Reply to comments by Reviewer 1

Ferdinand Seel on behalf of the authors
IAG, University of Stuttgart

Reply to comments by Reviewer 2

Reply to comments by Reviewer 3

Figure 1: FFT of F_y for the DesNoVG case over the radial direction.

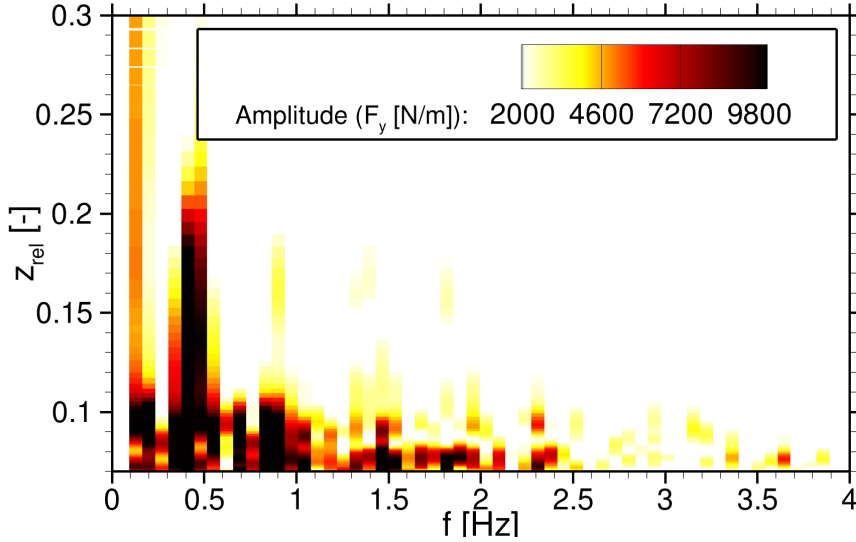
10. "Fig 7: I might be getting this wrong, but by visually examining fig. 7 I understand the following: From the F_y timeseries, there are at least two separate (?) dominant frequencies here. A 'slow' one with an average period of 2.3 sec appearing at $z > 0.1$ and a 'fast' one appearing at $z < 0.1$ with an average period of 1.15 sec. Intriguingly the periods have a ratio of two. I have tried to visually show this with the red squares in the F_y plot. I have pasted the same red squares to the dw/dt plot. I can see the 'slow' frequency, but instead of the fast one, I think an even faster one appears, with ($T = 0.5$ sec). Obviously, this is not the way to analyse this and a PSD spectrum would provide more insight. Have the authors looked into this? Finally, as w is an integral quantity, did the authors examine the dependence of the frequencies/phenomena on the extent and on the chordwise location of the WN region?"

Thank you for this detailed comment. The authors agree on the fact, that there are two frequencies and adapted it in the text (see **R3:S12-a** (page 13, line 298), **R3:S12-b** (page 13, line 307), **R3:S12-c** (page 13, line 310), **R3:S12-d** (page 14, line 320) and **R3:S12-e** (page 14, line 336)).

We intentionally decided not to do spectral analysis because the time samples are short enough to visualise it in time and see the differences between each period. Furthermore, a spectral analysis would require a much longer signal to reach statistical convergence of the detached flow. Such a computation would lead to excessive computational costs. Finally, the analysis of the blade without VGs was not meant to be the main focus of this publication and would stretch this section too much and would increase the length of the paper. The authors would

Nevertheless, in order to give a deeper insight to the reviewer, the authors undertook the spectral analysis through a Fast-Fourier-Transform (FFT) of the DesNoVG case (see attached Figure ??). The two discussed phenomena (i.e. slower and faster) are clearly visible through the FFT.

Figure 2: FFT of F_y for the oDesNoVG case over the radial direction.

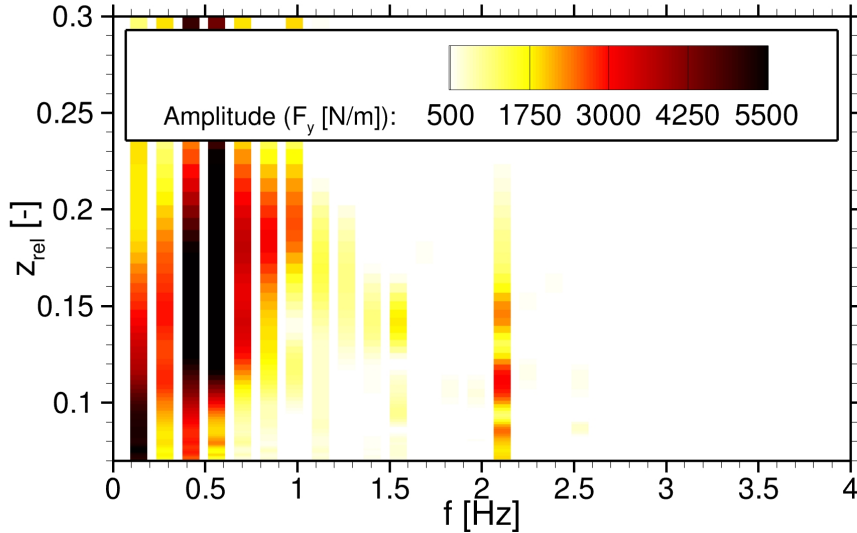
18. "*Fig. 9: Again, I might be wrong, but it seems that the 'slow' phenomenon of $T = 2.3$ sec is still present, whereas the faster one has disappeared or is less pronounced? I think a spectral analysis is would help a lot.*"

For the reasons already discussed in reviewer comment 10 the authors would kindly ask the reviewer to not investigate deeper the noVG case. This is also in agreement with the wishes of the two other reviewers, who proposed to rather shorten the publication than do further investigations. Nevertheless, we agree totally that a spectral analysis would give more insight and further discussion.

For this case, the time sample is even shorter than the DesnoVG case by a factor of 2. Consequently, the statistical convergence is even worse. Nevertheless, the FFT is represented in Figure 2. As mentioned by the reviewer, the higher frequency phenomenon is clearly reduced, whereas the slower one is still pronounced.
